CMD: 24-H2

**Ontario Power
Generation (OPG), Inc.**

**Darlington New Nuclear
Project (DNNP)**

- CNSC staff's review and assessment of whether the DNNP Environmental Assessment is applicable to OPG's selection of the General Electric Hitachi BWRX-300 Reactor

Figure 1: Comparison between the EA bounding reactor scenario and estimated BWRX-300 radiological emissions to atmosphere for a four-unit deployment (airborne releases)

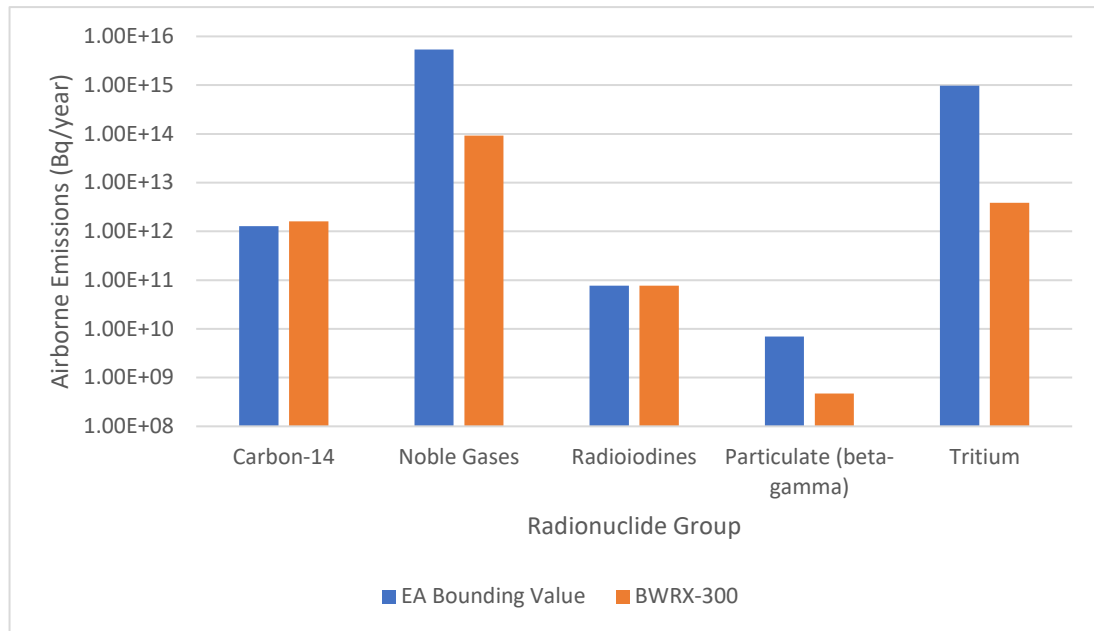
Figure 1 provides a comparison between airborne releases to the environment documented in the EA and estimated for the four-unit deployment of the BWRX-300 reactors.

OPG conducted a study to compare the effect of these release parameters to those assessed in the EA, and to determine whether the change in emission values (e.g., those for airborne radioiodines) remained within the bounding dose to a member of the public assessed in the EA. OPG calculated radiological doses to members of the public [13] using modelling consistent with the existing nuclear facilities, including the default parameters identified in CSA standard N288.1 – *Guidelines for Modelling Radionuclide Environmental Transport, Fate, and Exposure Associated with the Normal Operation of Nuclear Facilities* (2020 edition) [14].

Figure 2: Comparison of occupational radiation dose to NEWs from the deployment of a single-unit and multi-unit BWRX-300 and the dose assessed in the EA

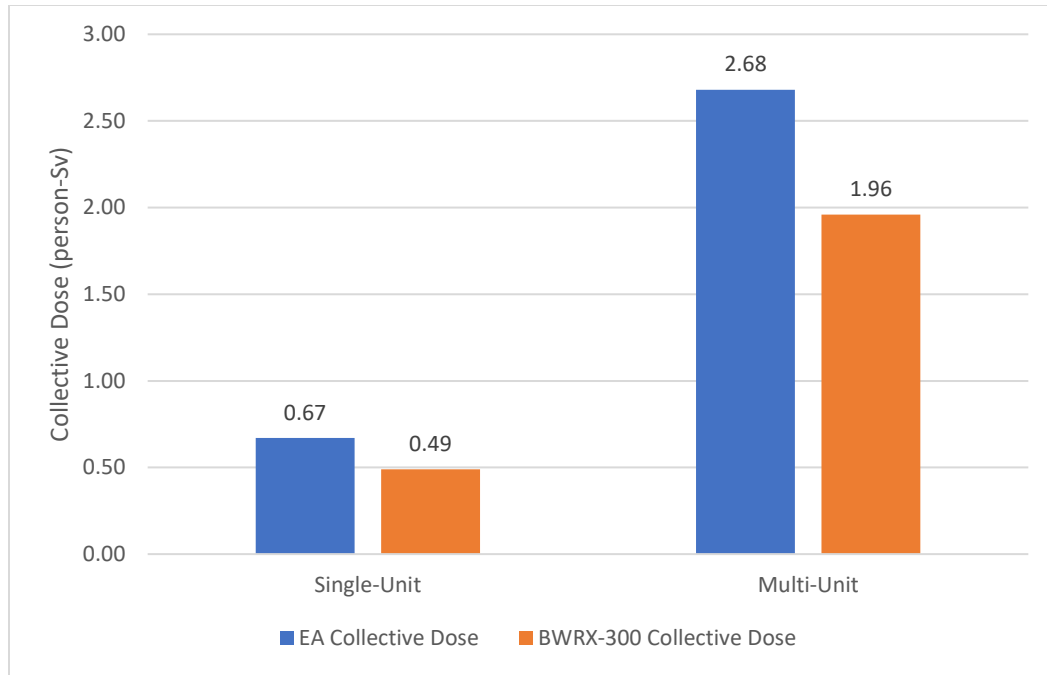
Figure 2 below provides a comparison of occupational exposure to NEWs between the bounding scenario assessed in the EA and the deployment of the BWRX-300 reactors, for both a single-unit and up to four reactors.

Radiological doses to NEWs from a multi-unit BWRX-300 deployment are predicted to be within the regulatory dose limits in sections 13 and 14 of the *Radiation Protection Regulations* during normal operations and maintenance outages, and controlled consistent with subsection 4(1) of the *Radiation Protection Regulations*. This prediction continues to be within the bounds of the EA.
